TOLEDO - LUCAS COUNTY PLAN COMMISSIONS

REF: SUP24-00106

SUBJECT: Special Use Permit for new building for school at 2323 W Bancroft Street

ELEVATIONS

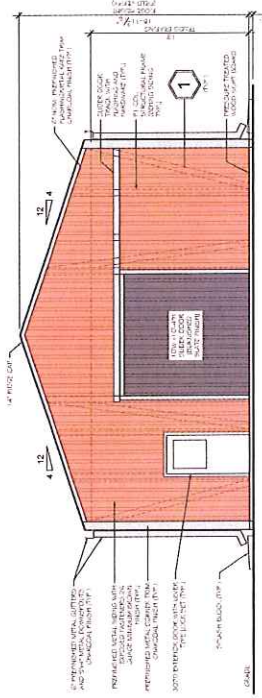
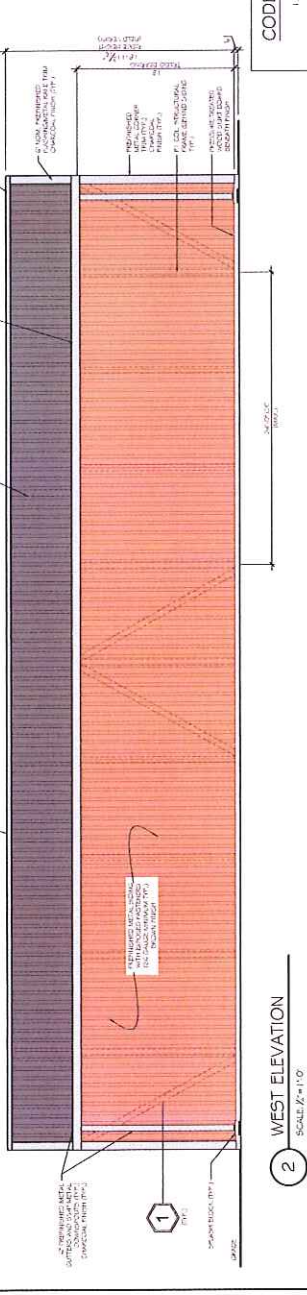
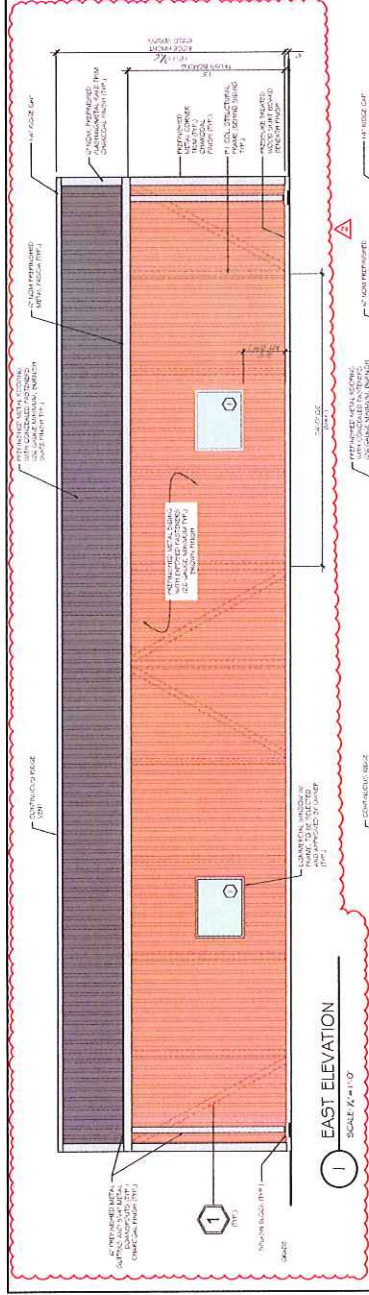
Institutional buildings are subject to TMC§1109.0500 *Building Façade Materials and Color*. The proposed metal material will be 26-gauge minimum and is considered a predominant material. Staff requests that the proposed exposed fasteners be revised and kept to a minimum. Due to the proximity of the proposed structure to the abutting residential district, the Planning Director also requested that the applicant revise the original elevations to depict earth-tone colors. In response, revised elevations were submitted that depict brown, charcoal, and slate shades, which are acceptable earth-tone colors.

14. Elevations must adhere to TMC§1109.0500 *Building Façade Materials and Color*. **The proposed metal material will be 26-gauge minimum and is considered a predominant material and is acceptable, however, Staff requests that the proposed exposed fasteners be revised and kept to a minimum.**
